Safety Evaluation Report

For the Moore Ranch ISR Project in Campbell County, Wyoming, Materials License No. SUA-1596

Docket No. 40-9073
Uranium One Americas, Inc.

U.S. Nuclear Regulatory Commission

Figure 2.4-6 68 sand potentiometric surface, March 2008 (adapted from Figure 2.7-2-7e of the technical report)

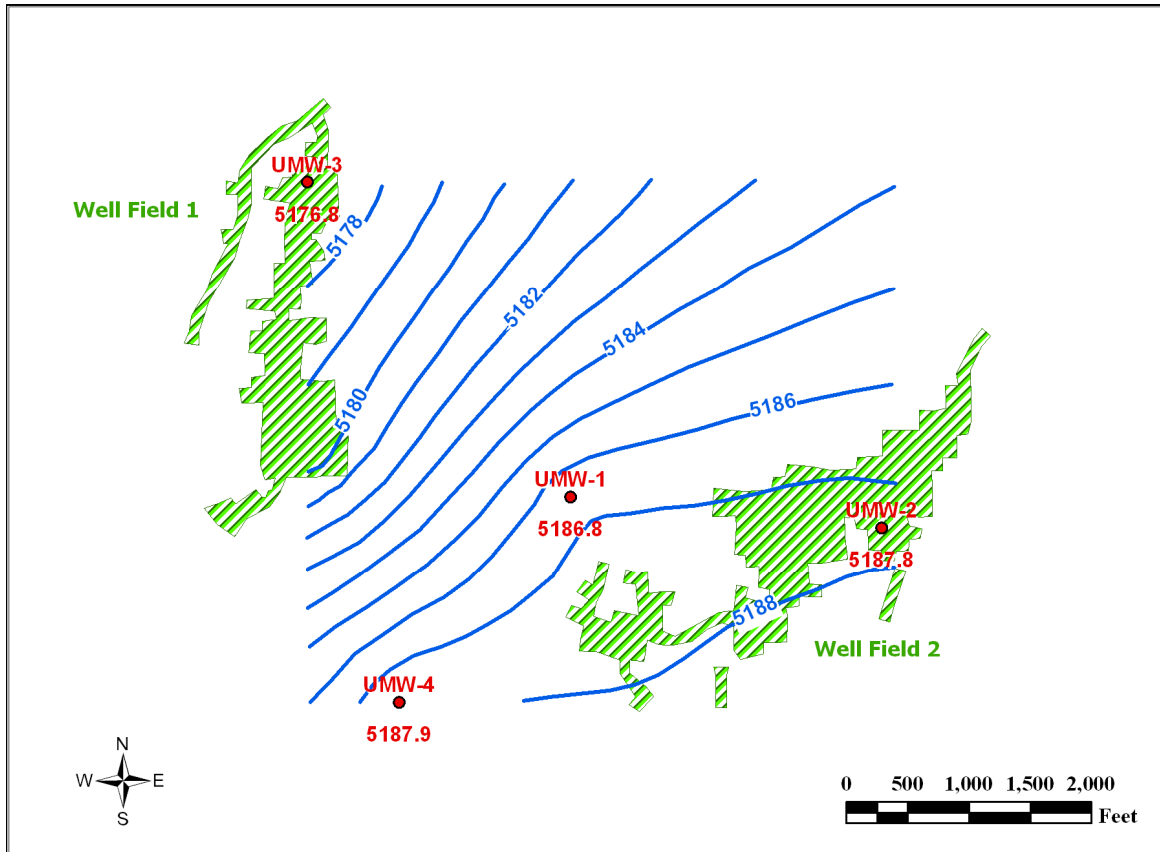
The underlying aquifer to the 70 sand extraction zone is the 68 sand. The applicant measured water levels in the 68 sand using four wells, UMW-1, UMW-2, UMW-3, and UMW-4, across the license area as shown in Figure 2.4-6. The applicant provided a hydrograph of the water levels from December 2006 through February 2008 in the 68 sand for the four wells in Figure 2.7.2-7f of the technical report. This hydrograph shows that UMW-1, UMW-2, and UMW-4 displayed relatively constant water levels in the 68 sand over this time period. However, UMW-3, located in the northern tip of Well Field 1 showed a slow 7.62 m (25 ft) decline in water level from February 20, 2007, to July 2007, which recovered partially by October 2007. The applicant conducted a 4-day pumping test in Well Field 1 in February 2007 on MW-3 in the 70 sand directly above UMW-3 at the same time this drawdown began.

The applicant conducted an investigation of other possible causes for the water level decline in UMW-3 during this time period. It examined the area near UMW-3 for the presence of nearby pumping wells in the 68 sand or 70 sand or in the deeper CBM wells that could have impacted the well. No pumping well activity that could have been the cause was discovered. In addition to this event, UMW-3 also experienced another separate water level decline of about 21.33 m (70 ft) on October 3, 2007, which the applicant attributed to a sampling event. The well recovered by 15.24 m (50 ft) in 1 month and returned to its original water levels by February 2008. Recently, in August 2009, the water level in the well was anomalously high. The behavior at UMW-3 has led the applicant to conclude the transmissivity in UMW-3 is low due to well completion damage or natural causes. The applicant stated it will continue to monitor this well closely.
